MODEL BENTLEY MARK VI

MODIFICATIONIGNITION COIL INPUT SUPPRESSOR

Bulletin

MODIFICATION.HORN PUSH BUTTON ASSEMBLY.

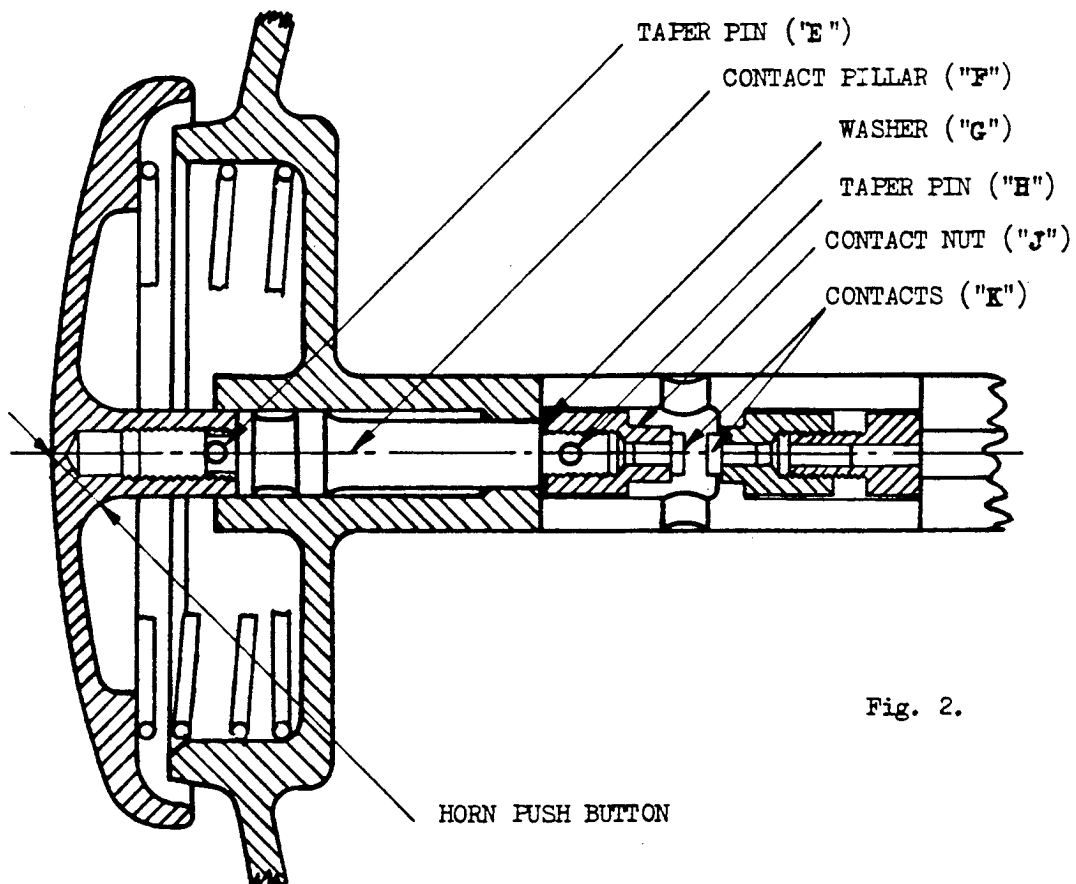
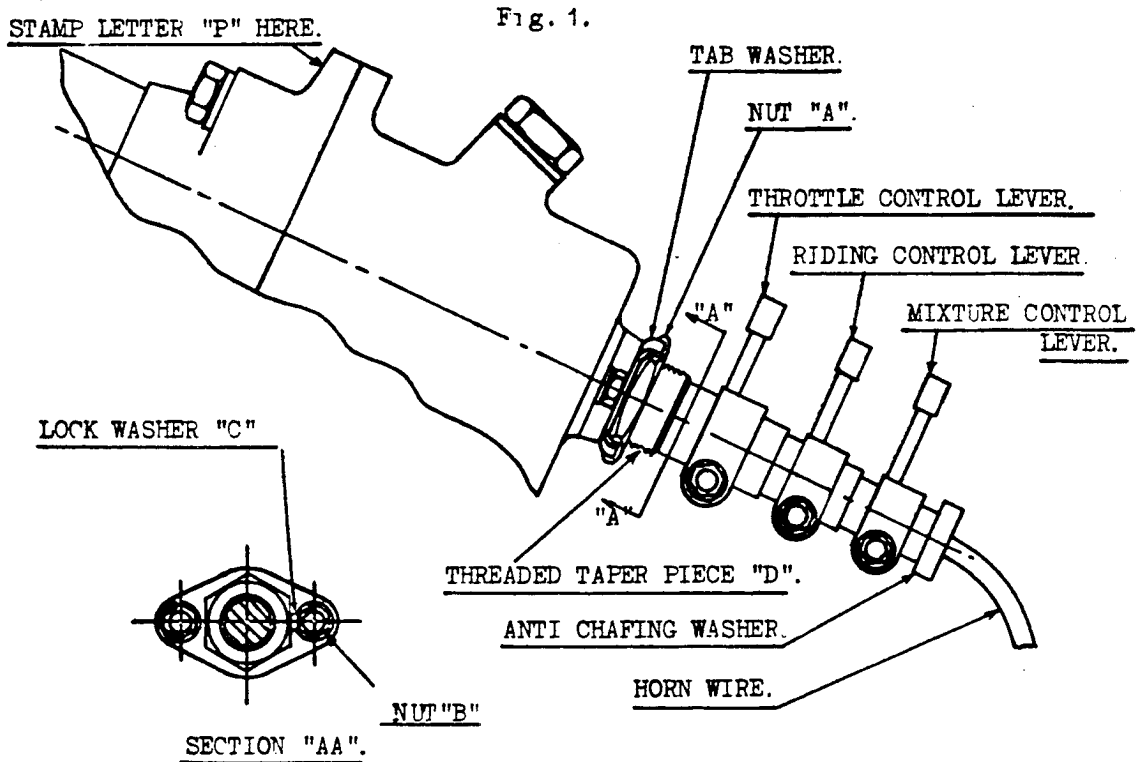
A modification is introduced to the horn push button assembly to give additional strength where the contact pillar is screwed into the horn push. The alteration consists of the substitution of the taper pin locking by sweating.

From the horn push button unit tap out the taper pin 'H' and remove the contact nut 'J' and the brass washer 'G'. The push button and its contact pillar 'F' is now free to be removed from its cover.

Tap out the taper pin 'E' from the contact pillar and unscrew the pillar from the button. This contact pillar, with holes drilled through both its threaded portions, and the taper pin 'E' can be discarded.

A new contact pillar, with its top threaded portion tinned with solder is screwed and sweated into the push button.

A distance of .040" between the contacts is desirable, and this is obtained as follows:-

The amount of this travel is regulated by the thickness of the brass washer 'G'. If the horn sounds before the button nips the feelers, the brass washer requires reducing in thickness, but if a greater travel than .040" is obtained before the horn sounds, then a thicker washer is required.

When the correct amount of travel is obtained, the contact pillar is drilled through the existing holes of the contact nut 'J' and the taper pin 'H' fitted. The unit may now be finally refitted in the steering wheel hub.

Stamp the letter 'P' on the near-side lug of the steering box as indicated in the drawing.

RADIO INTERFERENCE.

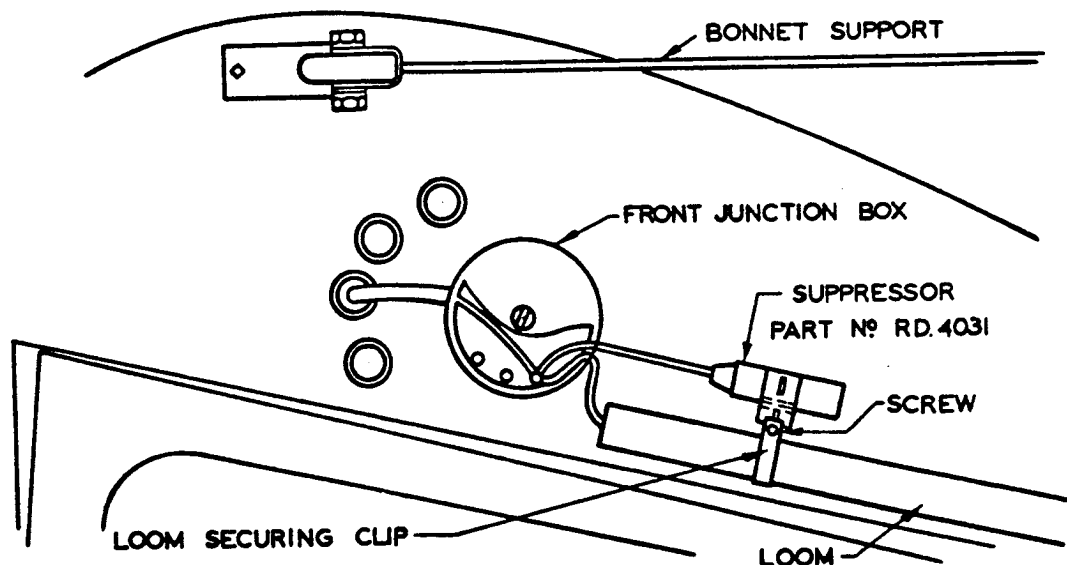
A few cases of radio interference from the "Windtone" horns have been reported.

To obviate this, a modification is to be introduced incorporating a suppressor condenser within the horns.

Where this trouble occurs on chassis without the modified horns, it can be eliminated by fitting an external suppressor in the feed circuit to each horn junction box.

1. Remove the screw holding the loom securing clip to the inside of the wing valance.
2. Slip the suppressor bracket between the wing valance and loom securing clip, locate the screw in the bolt hole, and tighten up.
3. Remove the cover from the front junction box and identify the terminal to which the horn INPUT lead is connected. (This can be readily identified by first locating the horn INPUT lead from under the wing.)
4. Connect the suppressor lead to same terminal. (Before carrying this out, cut off the flat terminal at free end of suppressor lead, remove the small rubber sleeve, and bare just sufficient wire to effect a satisfactory connection).
5. Replace the junction box cover, and secure same.

RUN OF WIRING, POSITION OF CLIP, RUBBER SLEEVES AND SUPPRESSORS.CARS ON WHICH MODIFICATION ACTION IS NOT NECESSARY:

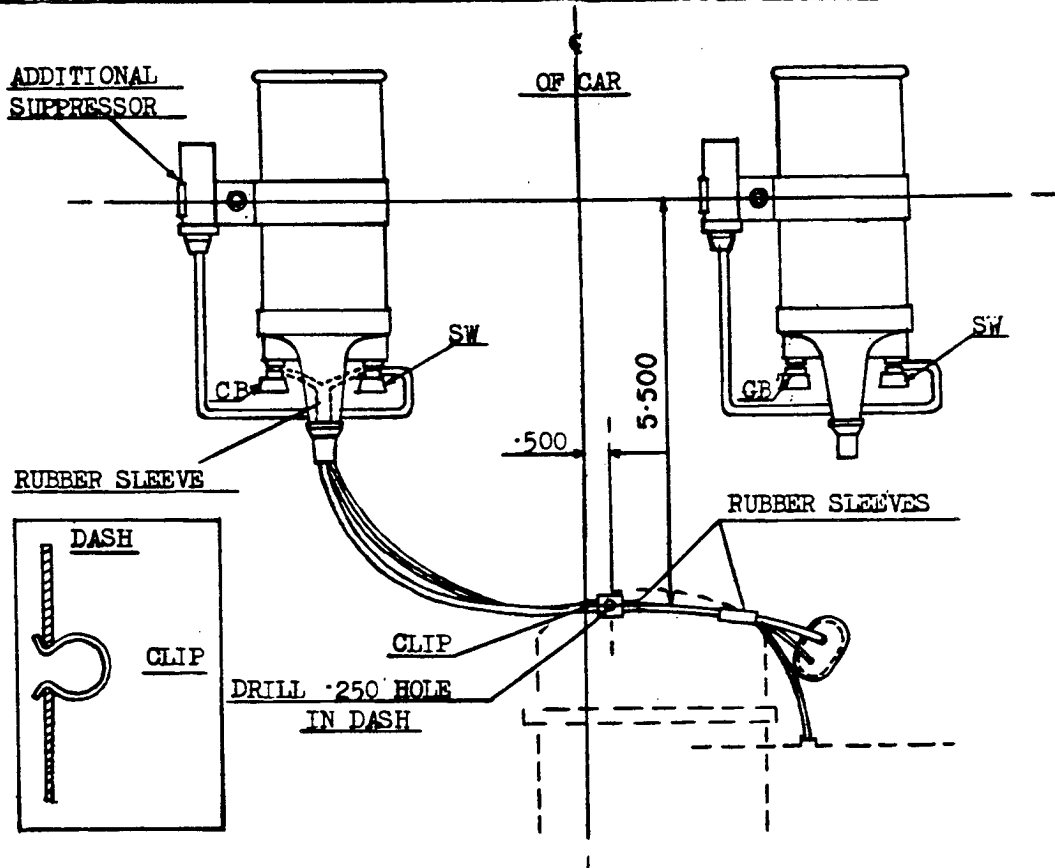
A modification is introduced to obviate the necessity for moving the existing ignition coil suppressor condenser when the spare ignition coil is being used. In conjunction with this modification, a clip is fitted to the dash to group the coil wires together and rubber sleeves to the wires to prevent chafing.

This is to be fitted to the off-side fixing bolt of the off-side ignition coil bracket and the suppressor lead connected to the INPUT (S.W.) terminal of the coil.

A hole .250" diameter should be drilled through the dash at the point indicated in the attached drawing. This position is immediately behind and on a level with the top of the rocker cover which can be removed to facilitate drilling the hole. The rocker gear should be covered to prevent the entry of swarf during the drilling operation. The drill should not penetrate the dash more than 5/16" as this will cause damage to the insulation situated immediately at the rear of the dash.

These should be positioned on the wires as shown in the attached sketch. The wires should be connected to the off-side coil, the radio switched on and the engine run to check the suppressor and the ignition coil for correct functioning. The wires can be left connected in this position, the near-side coil becoming the spare.

FIG. 1. STANDARD HEADLAMP WITH LIGHT UNIT REMOVED.

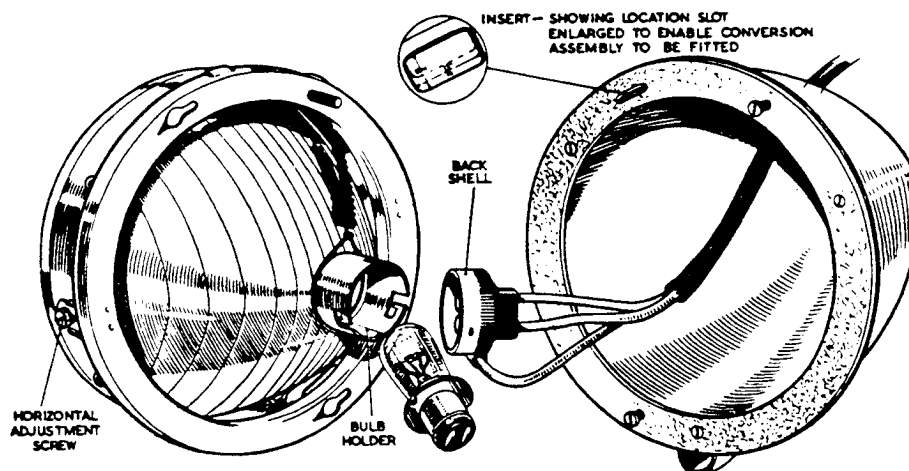
INSTRUCTIONS FOR FITTING 7" SEALED BEAM UNITCONVERSION ASSEMBLY TO LUCAS RF770 HEADLAMPS.FOR INFORMATION:

- (i) Remove the plated unit rim from the seating flange by taking out the two horizontal adjustment screws.

FIG. 2. CONVERSION ASSEMBLY FITTED.

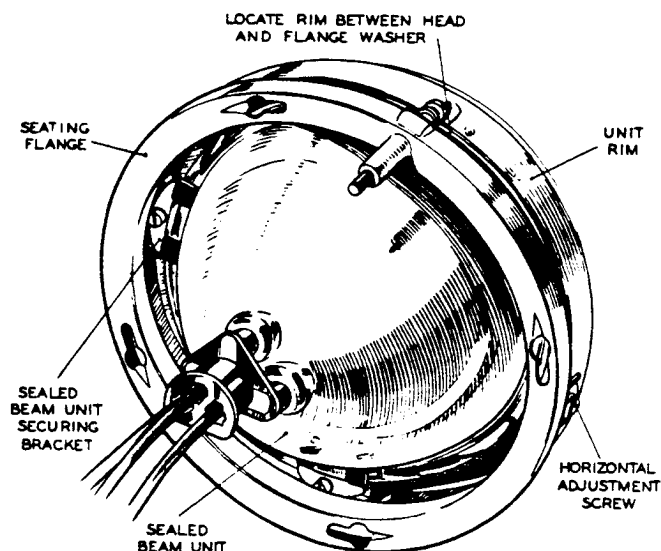
Connection to the Sealed Beam unit is made by means of a three point adaptor plug. To make the connections, proceed as follows:-

- (i) Bare approximately $\frac{3}{8}$ " of the cables.
- (ii) Remove the adaptor from the Sealed Beam unit.
NOTE: It will be observed that the rear of the adaptor is marked "Ground", "Pass" and "Drive".
- (iii) Remove the three spring contacts from the adaptor.
- (iv) Solder the core of the black cable to one of the spring contacts and fit the contact in the recess of the adaptor marked "Ground".

FIG. 1.

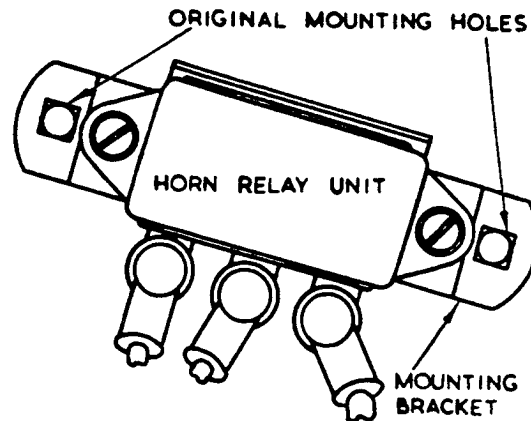
Retailers are advised that the Lucas C585K horn relay unit (Part No. RD-3084) as at present fitted, has been superseded by the Lucas SB-40 type unit (Part No. RD-6351), and that this is now the only replacement available.

Fig. 1 illustrates the general arrangement of the new assembly when installed on a car.

- 1) Remove the cover and disconnect the cable assemblies from the existing horn relay unit. Remove the relay unit from the valance plate.
- 2) Fit the new mounting bracket (RD-6352) to the valance plate, using the two shorter 2BA bolts supplied. Mount the replacement relay unit on to the bracket using the two 2BA cheesehead screws supplied.
- 3) Reconnect the cable assemblies to their respective terminals on the new relay unit.

FIG. 2. DRH. 8859 CONDENSER
(Current Replacement)

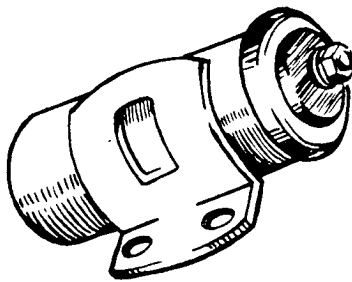
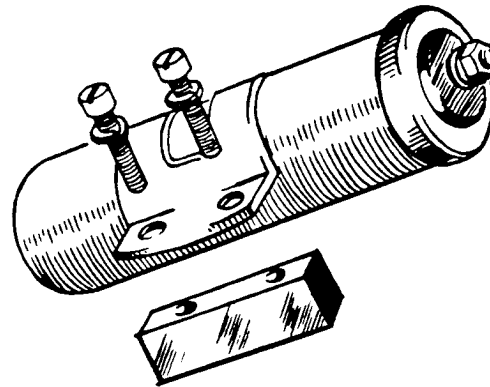
The ignition condenser (Delco-Remy Type DRH. 1386, Part No. RD. 6258) hitherto fitted on all chassis in production has been superseded by the improved DRH. 8859 type unit, which is now the only replacement available.

Although the new type condenser is interchangeable and is fitted on the distributor in a similar manner to the original unit, it will be observed from the above illustrations that a distance piece is also included. This is due to the difference in the relative angular setting of the mounting bracket.

Fig.1. DR 3. Type windscreen wiper motor.

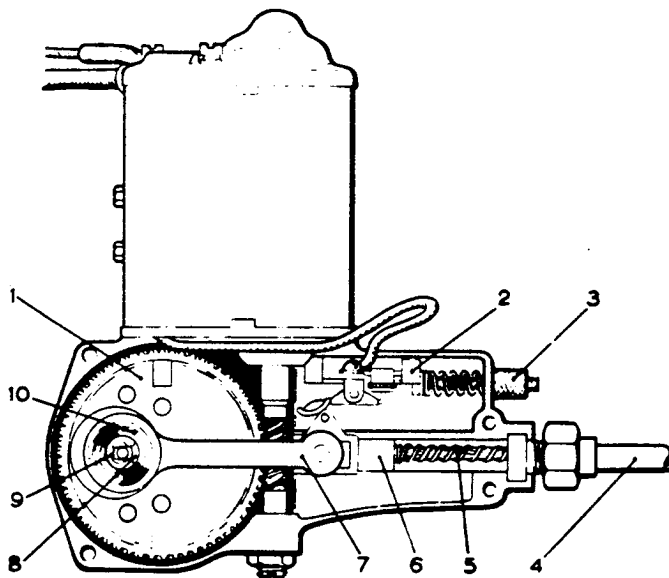
A new wiper motor (DR.3. type) is now being fitted to current production cars and by reason of its greater torque output and modified design, is an improvement on the DR.1. type motor which was fitted previously.

Attach the triangular bracket to the mounting plate, supplied with the new wiper motor, by means of two 2 BA screws.
